**PRODUCT SAFETY BULLETIN FP012506**

**Subject: FUEL PUMP SAFETY RECALL FP012506**

**Part Numbers: E7103M, E7115M, E7121M, E7122M, E7127M, E7128M, E7156M**

**Vehicle Applications:**  
1997-2001 Jeep Cherokee  
1997-2004 Jeep Grand Cherokee  
1997-2004 Jeep Wrangler  
2000-2003 Dodge Dakota Pickup

**AFFECTED FLANGE STAMPING NUMBERS**

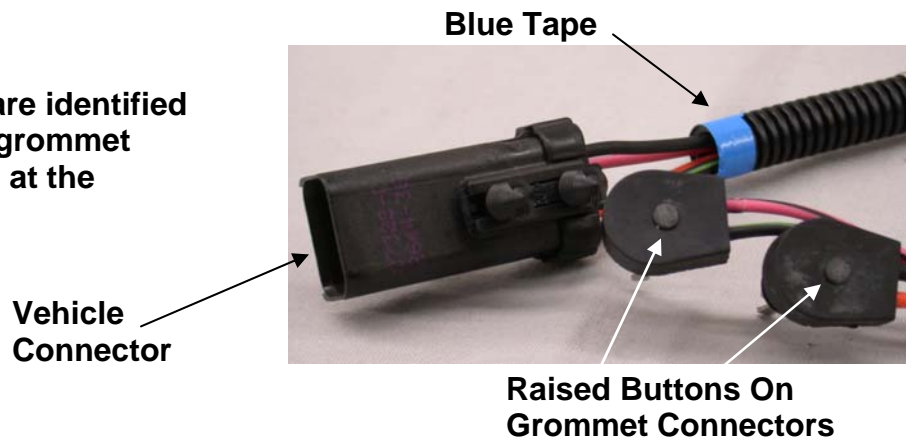
We have determined that there is a potential product safety related issue involving the above fuel pump modules. The plastic electrical grommet connectors at the top of the fuel pump module may degrade causing a potential leak path for fuel.

No occurrences have been reported in the field. To avoid any potential issues it is necessary that you and your customers return all of the above part numbers with top **flange stamping numbers EP98-48, EP98-49 and EP98-50**.

Modules installed during the following dates are affected and must be returned.

February 4, 2005 through January 16, 2006

**Good replacement units are identified by raised buttons on the grommet connectors and blue tape at the vehicle connector end.**
